**THE TOWN OF UXBRIDGE, MASSACHUSETTS  
ROADWAY & INTERSECTION IMPROVEMENTS PROJECT  
DOUGLAS STREET (ROUTE 16) AT  
WORCESTER-PROVIDENCE TURNPIKE (ROUTE 146)  
CONTRACT 2022-14**

**ADDENDUM #2  
March 16, 2022**

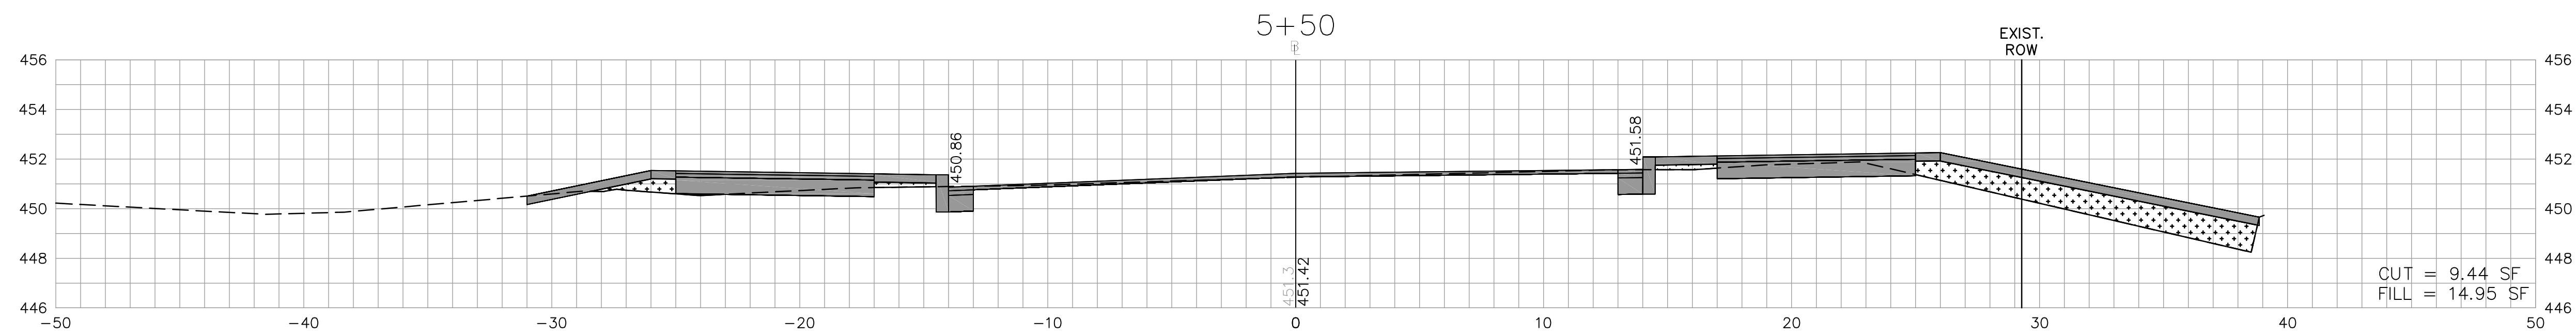
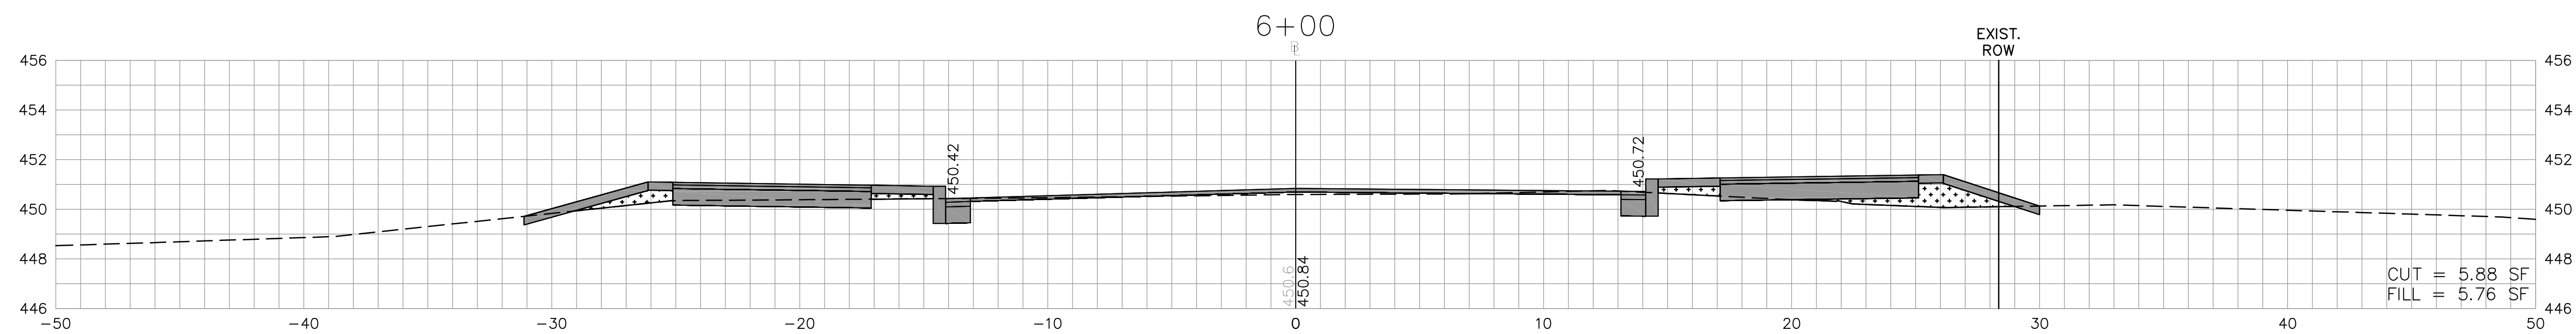
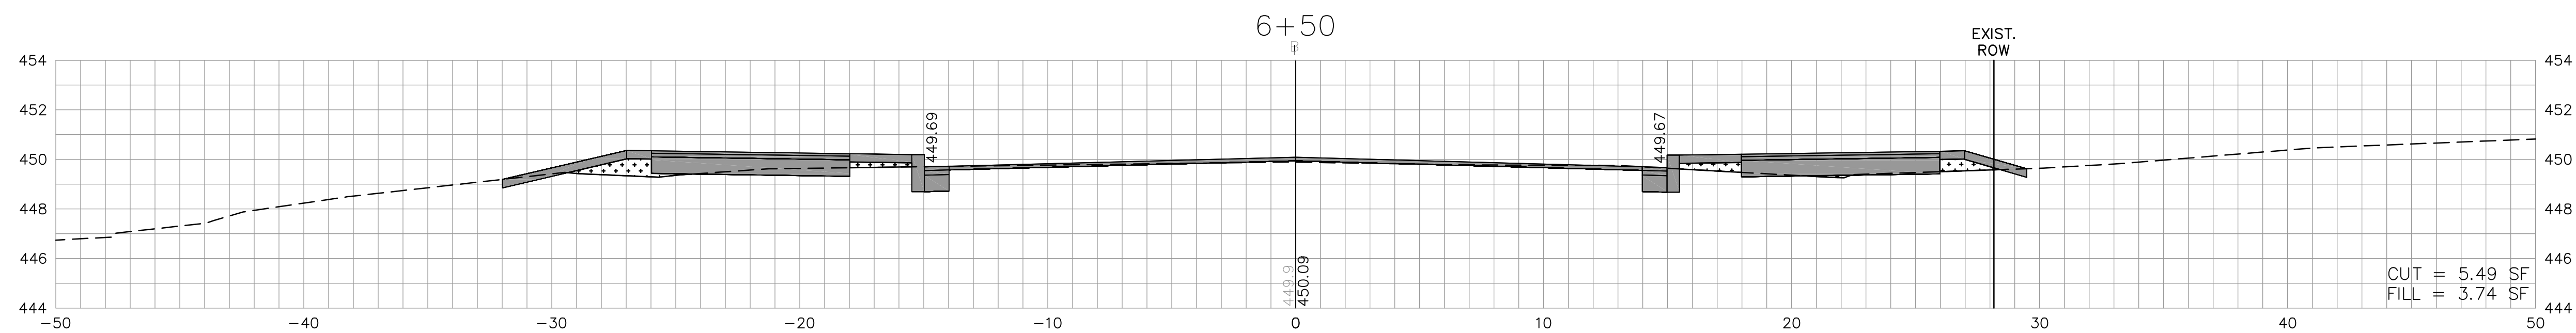
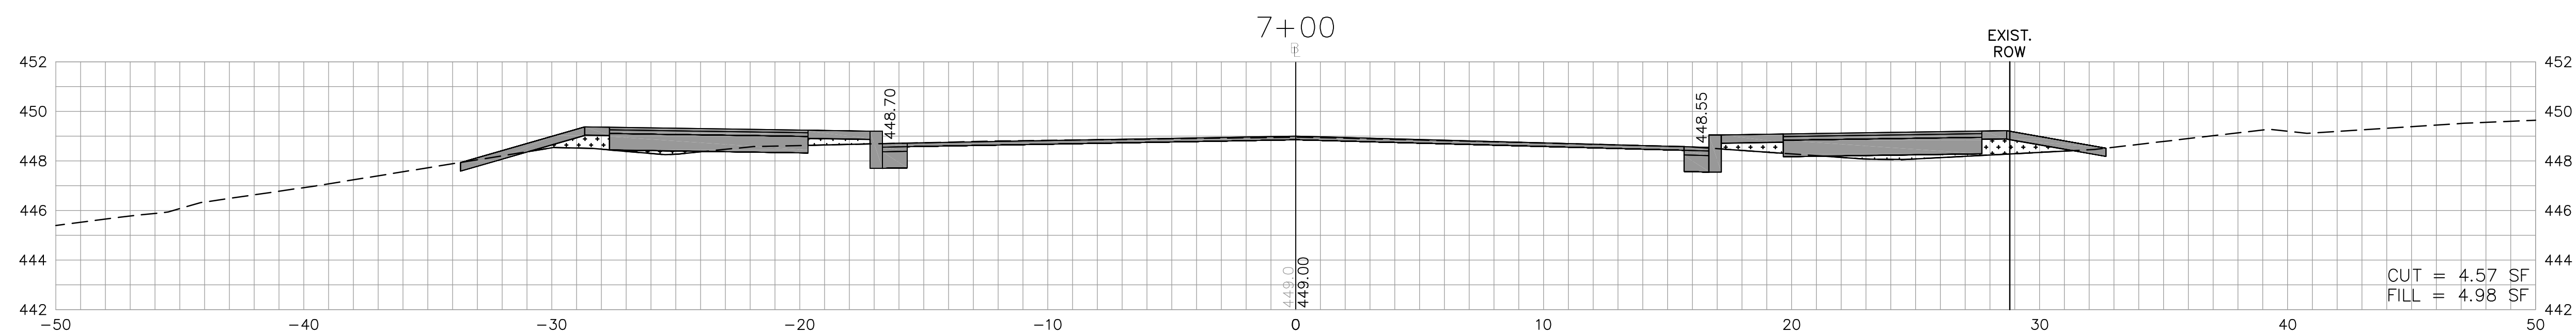
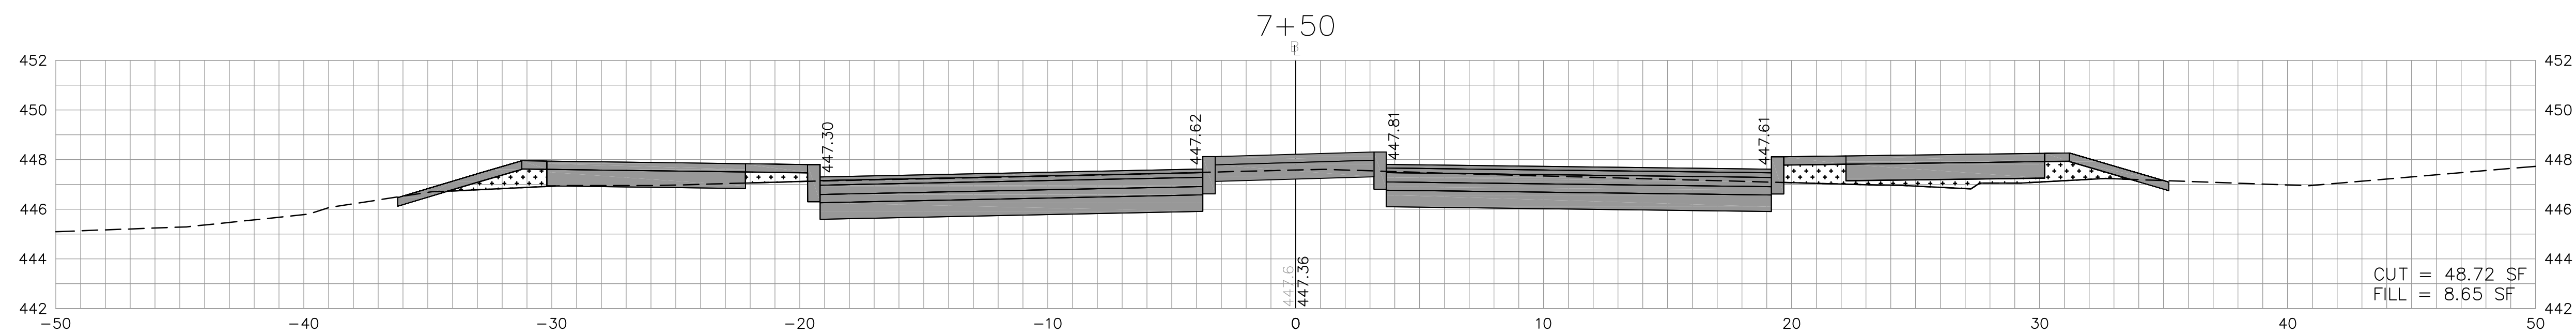
*This sheet was incorrectly numbered as sheet 89 of 106. It has been revised to read sheet 90 of 106 accordingly.*
